Technical Service Bulletin (TSB)
Radio Over The Air Update from
U31.42 to U33.43 Software Version (FOTA)

REFERENCE:	TSB: 08-215-24 GROUP: 08 - Electrical	Date:	October 2, 2024	REVISION:	-						
VEHICLES AFFECTED:	<p>2024 - 2025 (MP) Jeep Compass This bulletin applies to vehicles built on or before November 11, 2024 (MDH 1111XX) equipped with a Global Telematics Box Module (TBM) (Sales Code RDG) and one of the following radios:</p> <ul style="list-style-type: none"> • Uconnect 5 Nav w 10.1" Display (USA) (Sales Code UBN). • Uconnect 5 Nav w 10.1" Display (CAN) (Sales Code UEN). 			<p>MARKET APPLICABILITY:</p>

**Fig. 1**

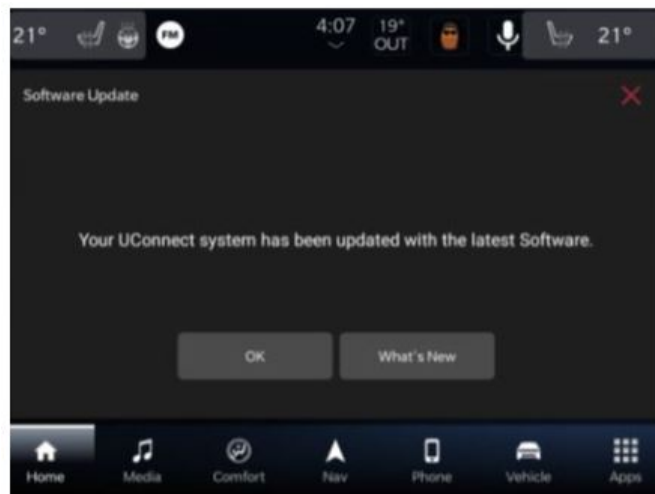
1. The vehicle needs to be in 'Park'. The ignition needs to be in the off position.
2. If the customer selects "Update Now" [Fig. 1](#) they can shut off the vehicle and leave. The update will be completed automatically.
